In re Application of	)	
	)	
<b>PANUNTO, John P.</b>	)	
	)	
Serial No: 10/660,533	)	Art Unit: 3653
	)	
Filed: 09/12/2003	)	Examiner: MORRISON, Thomas A.

For: **LARGE CAPACITY BOTTOM FEED DISPENSER**

**RESPONSE TO OFFICE ACTION DATED 01/03/2006**

Fig. 3

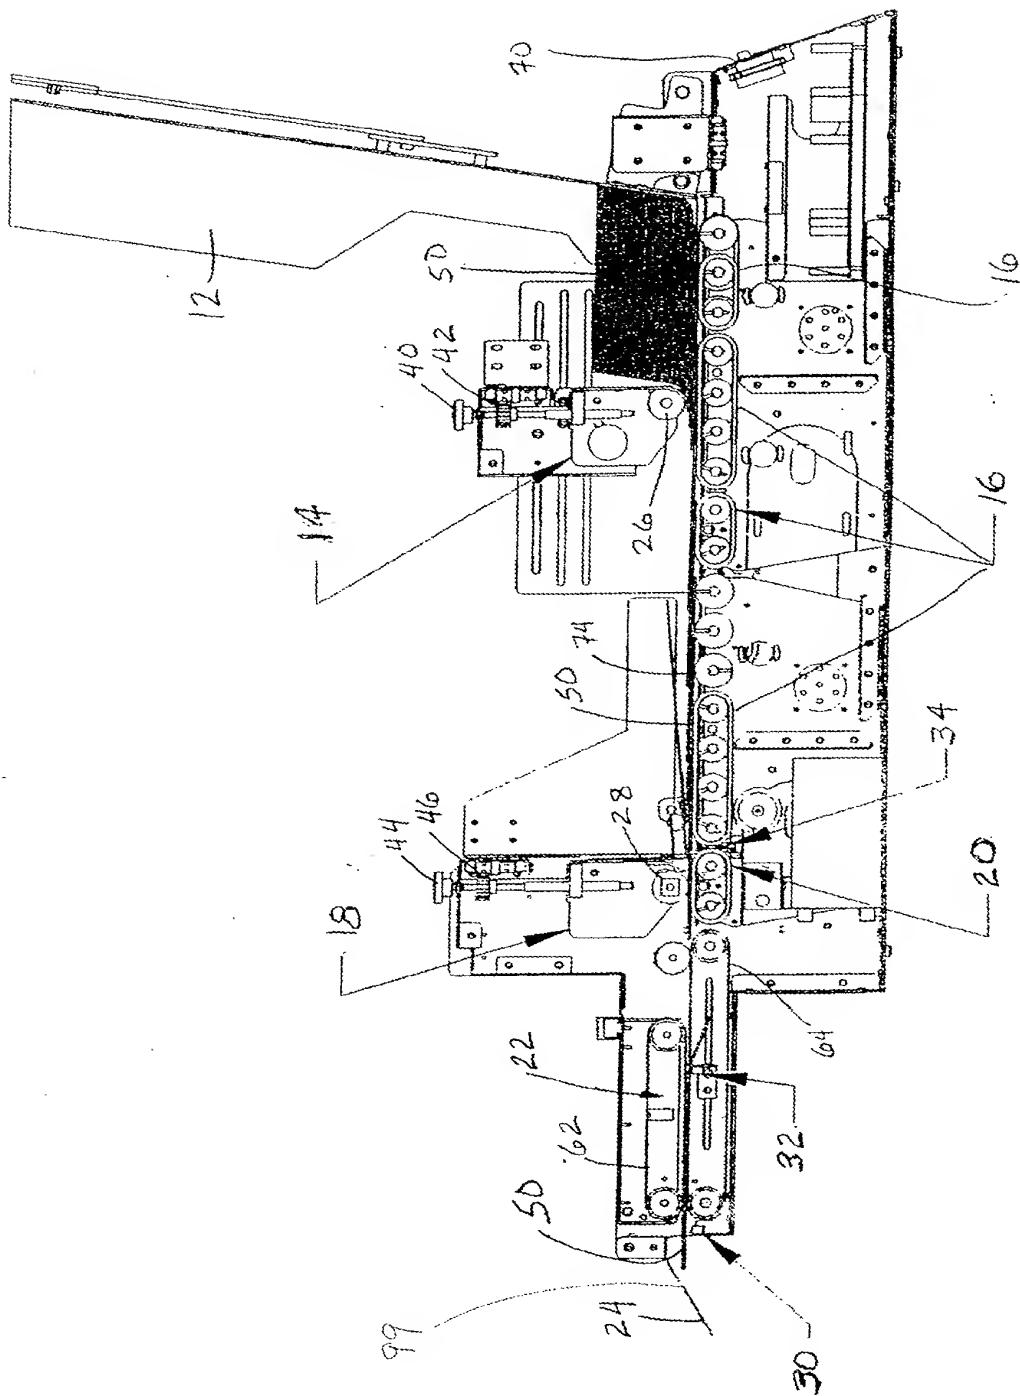
The attached sheet of drawings includes changes to Figure 3. This sheet replaces original Figure 3.

The drawings were objected to because of the reasons set forth in section 1 of the Office Action. In response, Figure 3 has been amended to remove reference character 22 pointing to the axle of the transport conveyor. Figure 3 has also been amended to label the location of the box ready sensor 99. In a related amendment, paragraph [0054] has been amended to identify the “box ready sensor” as --box ready sensor 99--. In view of these amendments, it is respectfully submitted that the drawings are now in proper form, and withdrawal of the objection to the drawings is requested.
